PLANNED UNIT DEVELOPMENT

<u>& SUBDIVISION STAFF REPORT</u>
Date: July 8, 2010

DEVELOPMENT NAME Checkers Hwy 90 W. Subdivision

CONTEMPLATED USE Planned Unit Development Approval to allow two buildings on a single building site, and Subdivision approval to create 1 lot.

SITE PLAN

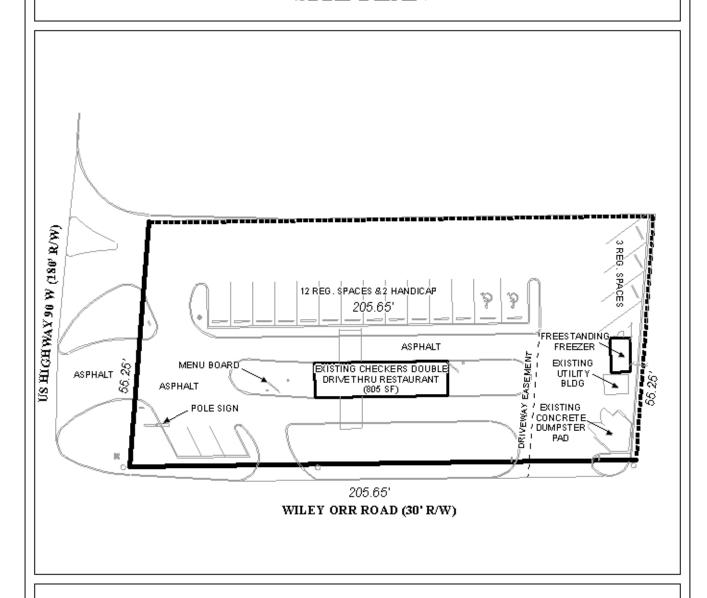
The 25-foot minimum building setback line is not depicted on the preliminary plat. The Final Plat should be revised to depict the 25-foot minimum building setback line along all rights-of-way, if approved.

- 1) submittal of a two lot subdivision application to include the remaining portions of Outlaw Land LLP RBP 4620 PG 91 (including the provision of new postage fees to allow for corrected notifications). Revisions and fees must be submitted by June 1st; and
- 2) revision of the plat to depict the 25' minimum building setback line along all street frontages.

- 1) inclusion of the property located to the North (Popeyes) as part of the PUD (showing parking, total building area and use, footprint area, landscape area, etc), with owner approval and new labels and postage for the entire notification area to be provided to Planning by June 1st, or revision of the site plan to eliminate shared access between the two sites; and
- 2) revision of the site plan to reflect compliance with Urban Forestry comments: Full compliance with frontage and parking tree requirements of the Zoning Ordinance to be coordinated with Urban Forestry.
